Office Action Summary

10/655,856

COBLENTZ, W. SAM

PALLET AND SPACER

2,683,010

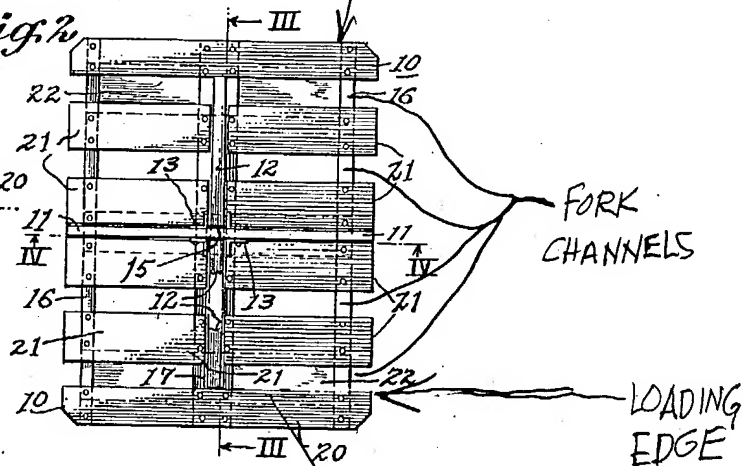
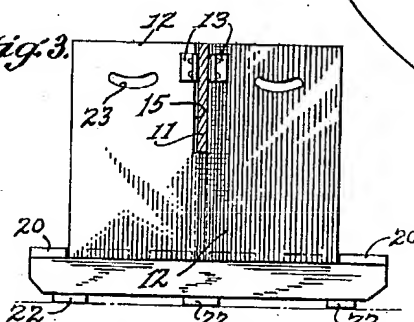
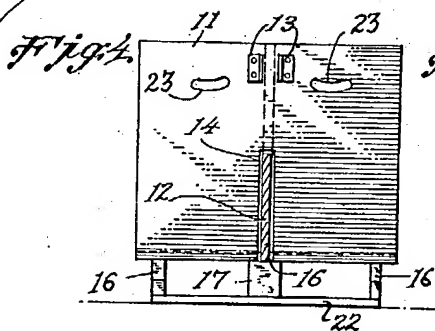
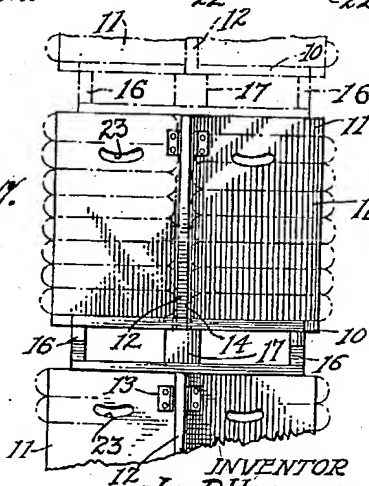
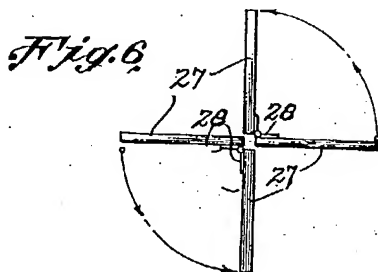
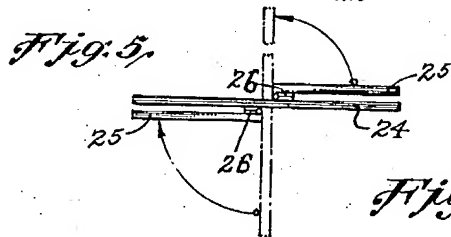
See the attached marked up copy of the cover sheet of Hammerslag, Jr. depicting the claimed features.

LOADING
EDGE

UPPER SURFACE

BASE

- FORK CHANNELS

-LOADING
EDGE

4 AREAS
for receiving
stocks

CONNECTOR

ANGLE
BETWEEN
16 & 20
form
connecto

that is
capable of
receiving
a lifting
device
